Subject: Attn: Planning Officer Thomas Burns - RE: Development Application DA2020/1691

Attachments: 4SouthernCrossWay-Objection_DA2020-1691-FIN.pdf; 4SouthernCrossWay-Objection_DA2020-1691-Plans_ljrMarkup.pdf;

RE: Development Application DA2020/1691

New - Demolition works of existing dwelling and construction of dwelling house, secondary dwelling and studio at 4 Southern Cross Way Allambie Heights NSW 2100.

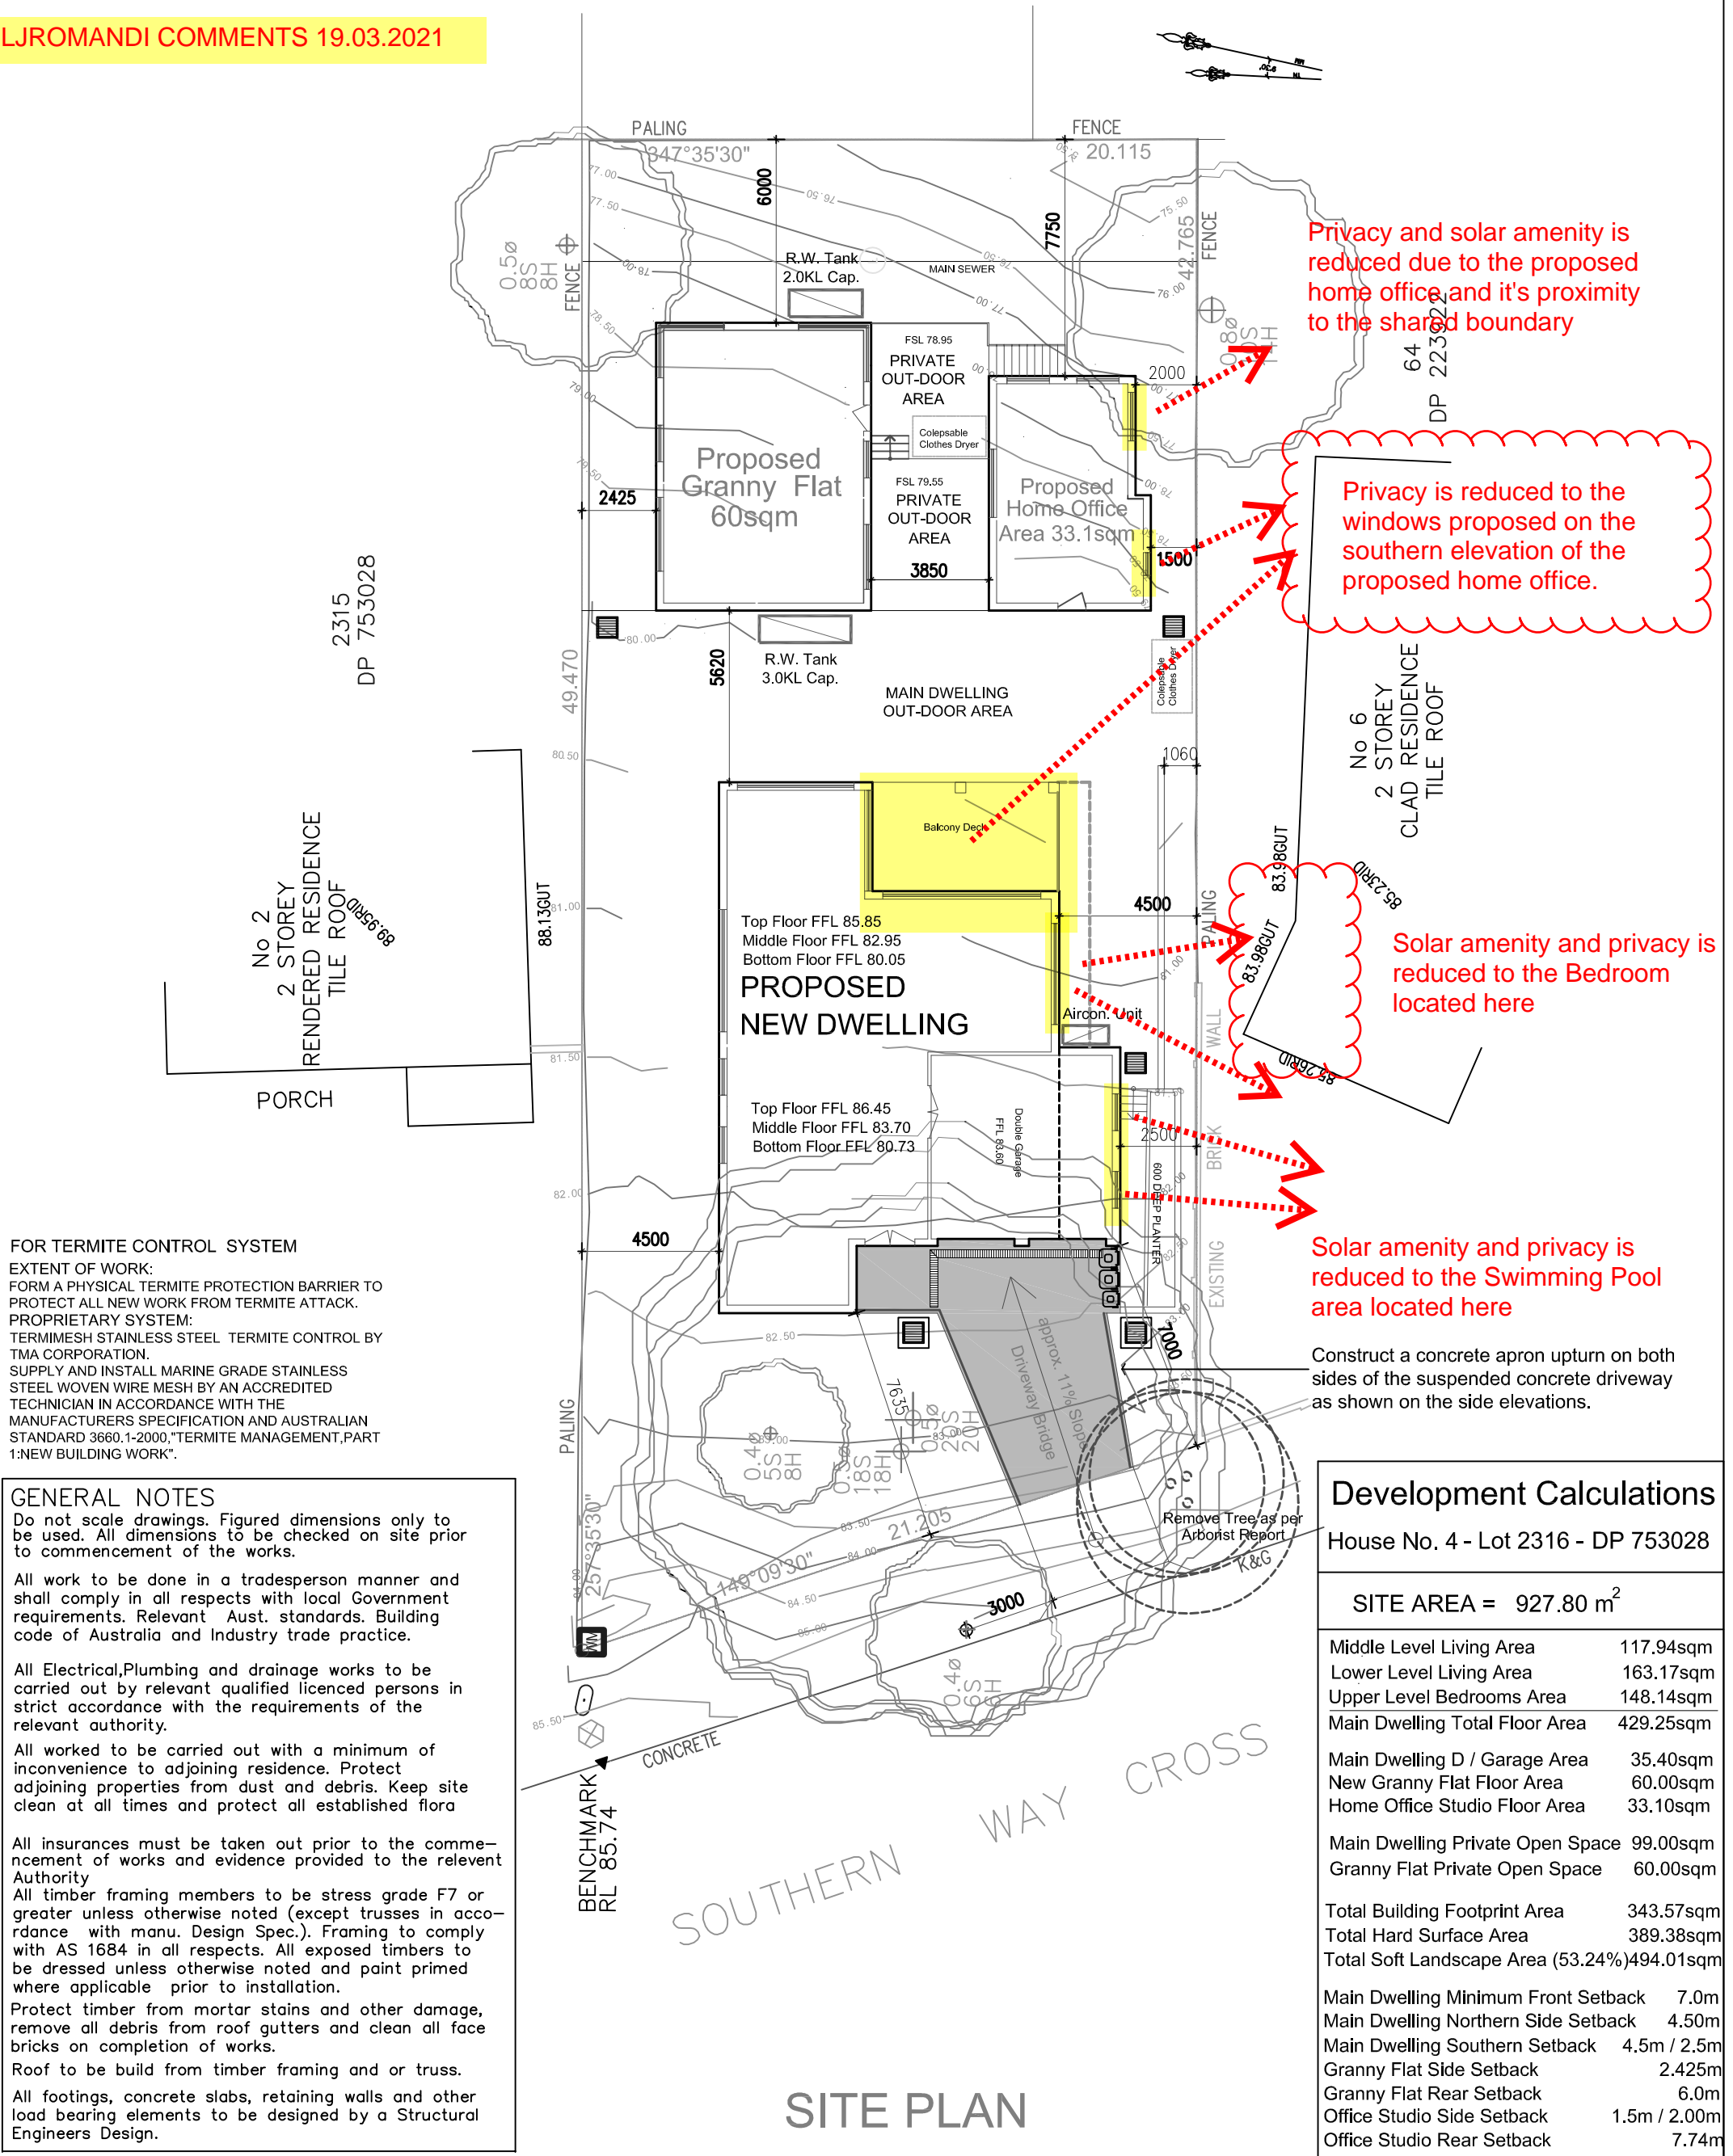
The placement of the main Air Conditioning Unit is directly adjacent to our master bedroom and swimming pool – areas of relaxation. At only a 2.5m setback this is actually one of the closest proximities to our house.

ADDRESS 4 Southern Cress Way Allambie Heights NSW		
CLIENT Mr. Chris Jaczac		
DRAWN AJ	SCALE 1:200	DATE 20201010
DRAWING No: PR020.03, Page 1		ISSUE A

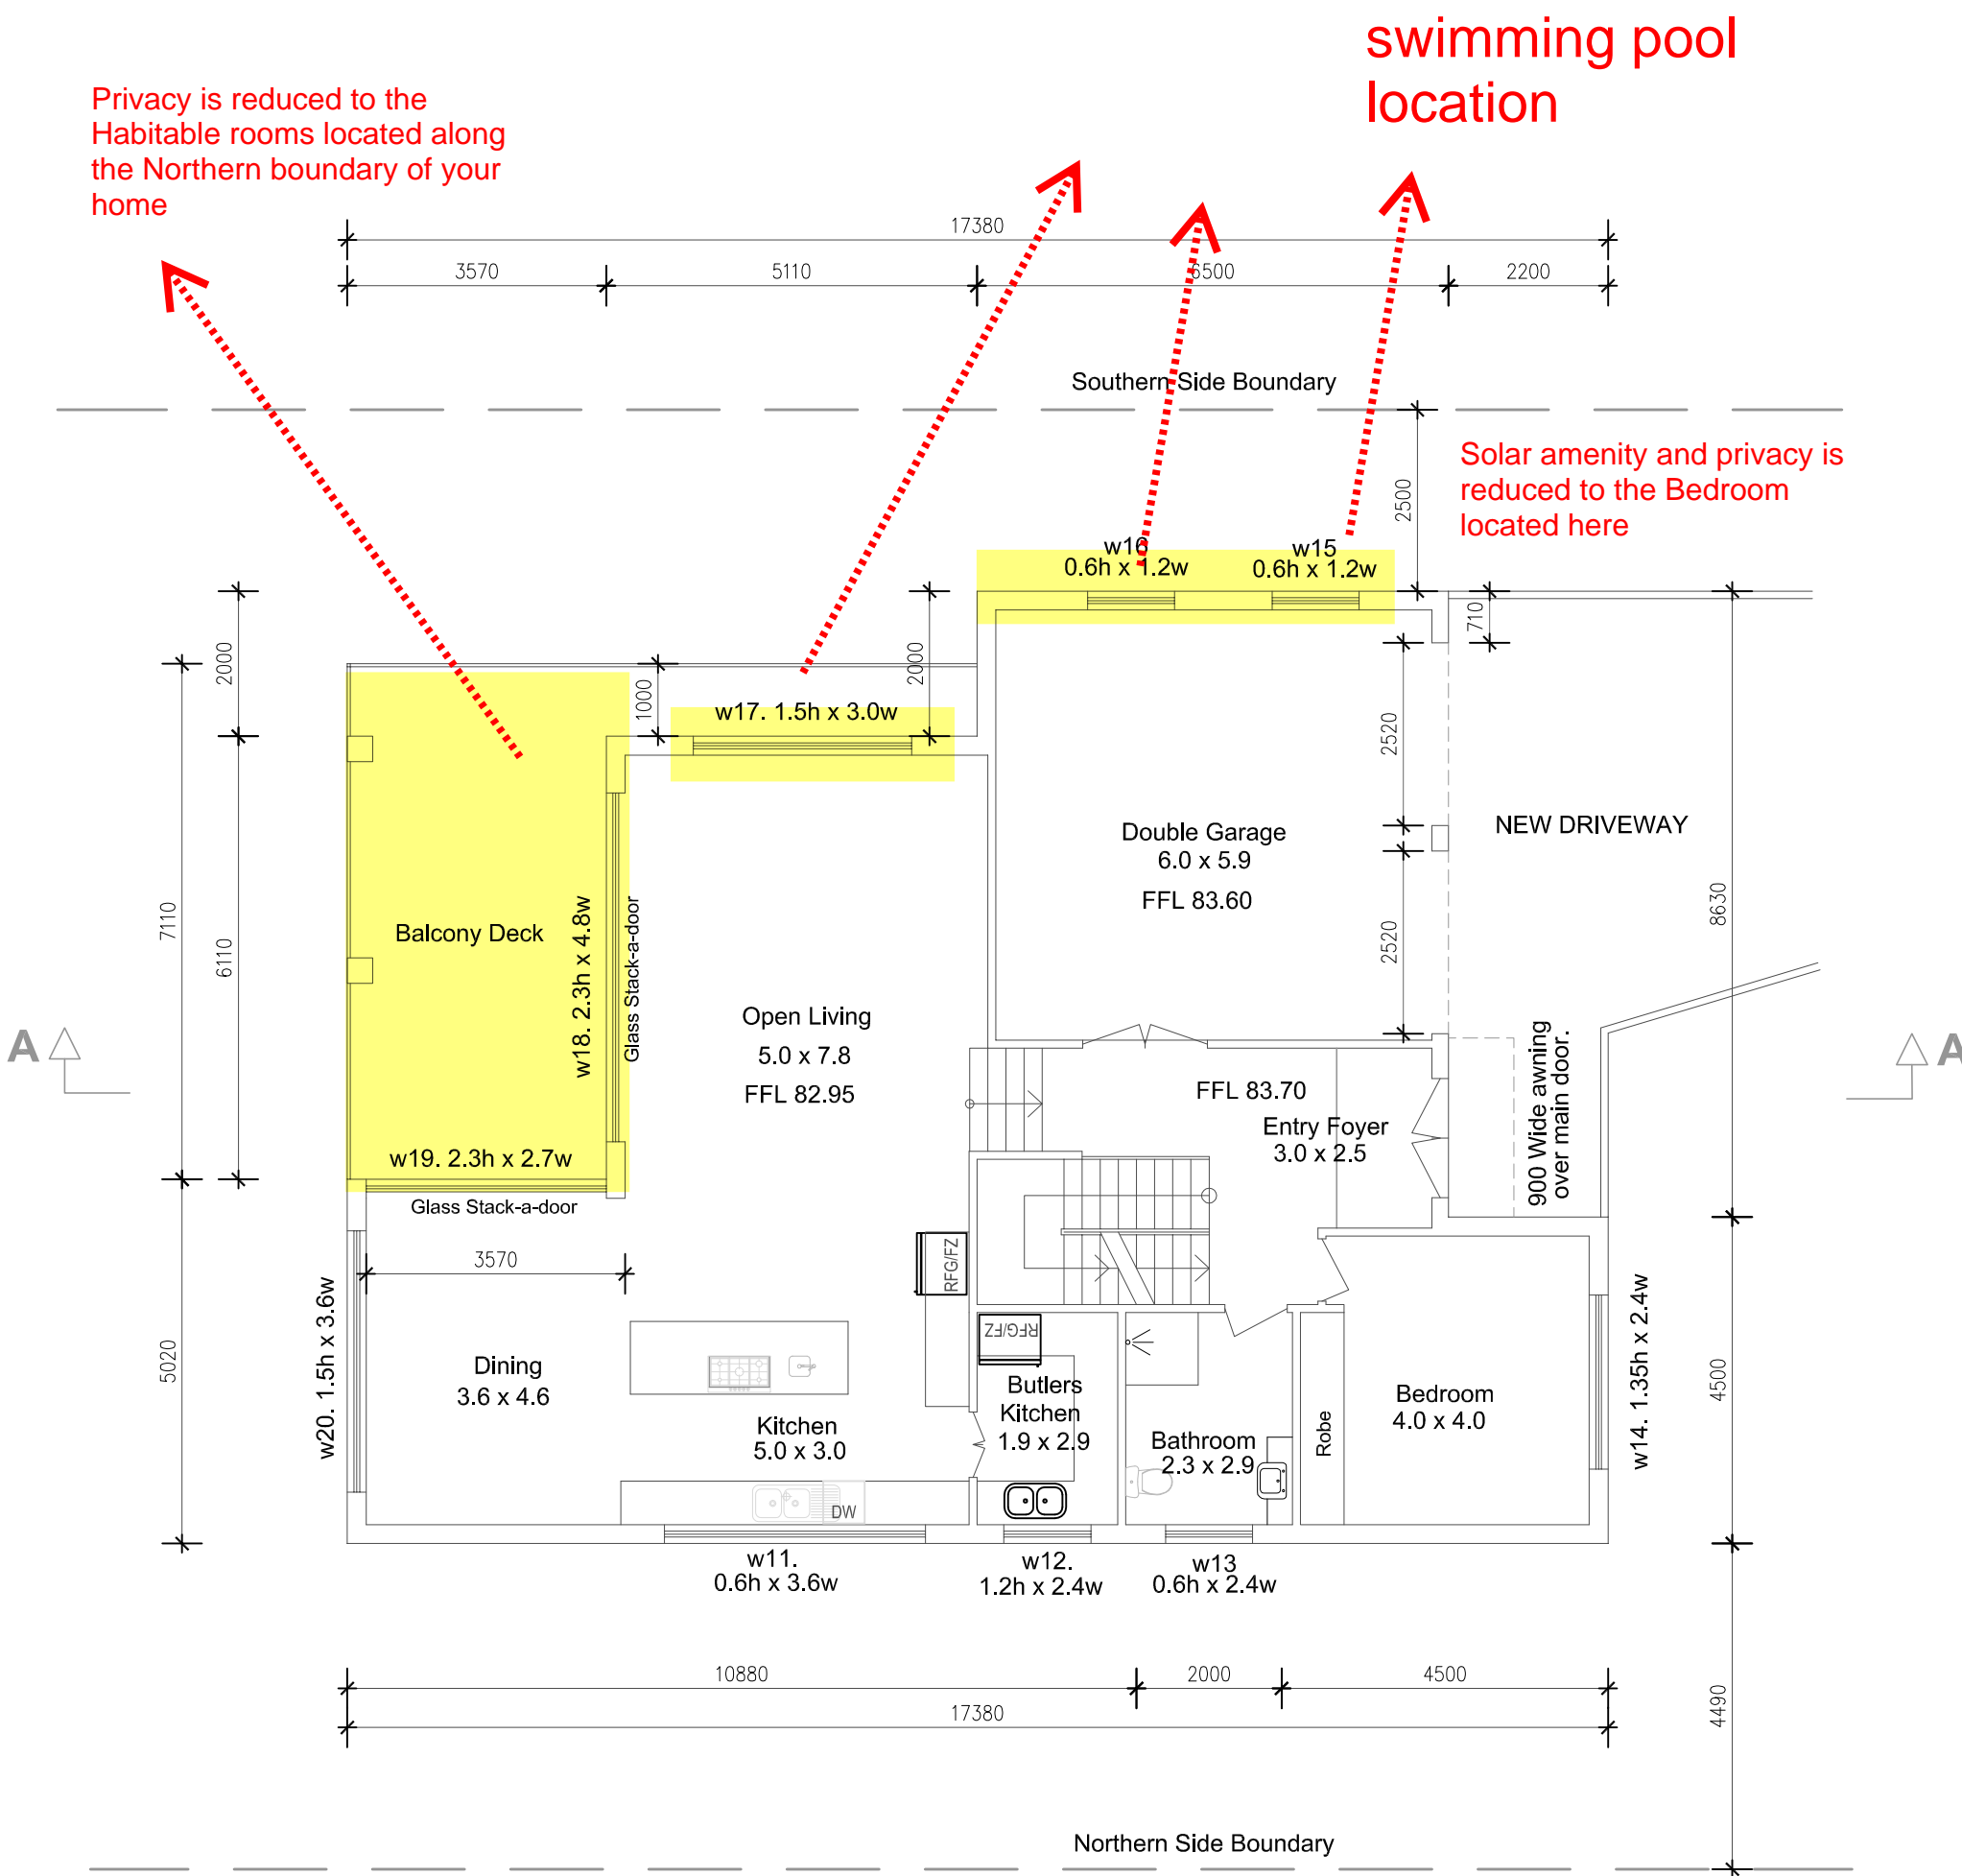
Although new trees are proposed, what are the impacts on our swimming pool area? There is potential increased shade/shadow, deciduous leaf/flower litter and roots potentially disturbing the pool foundations. The area calculations on the Site Plan seem incorrect.

LJROMANDI COMMENTS 19.03.2021

MAIN DWELLING MIDDLE FLOOR PLAN

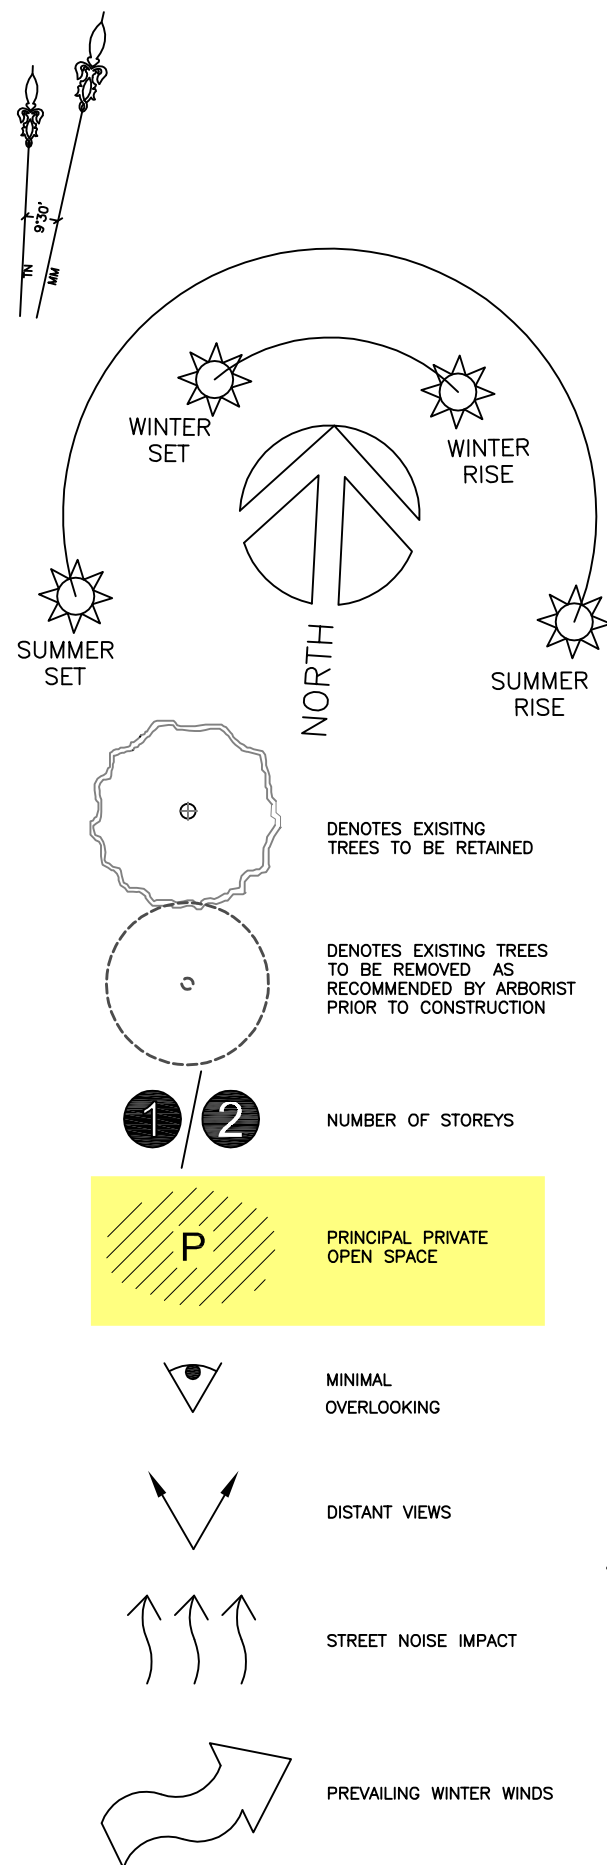
The proposed patio and balcony at the southern side middle level looks directly into our master bedroom and main living areas. Conveniently, no RLs have been shown indicating the sill heights of windows along our Northern façade.

The proximity to, scale and bulk of the main house, with the proposed balcony deck/patio on the southern side middle level and double garage windows look directly into our pool area.
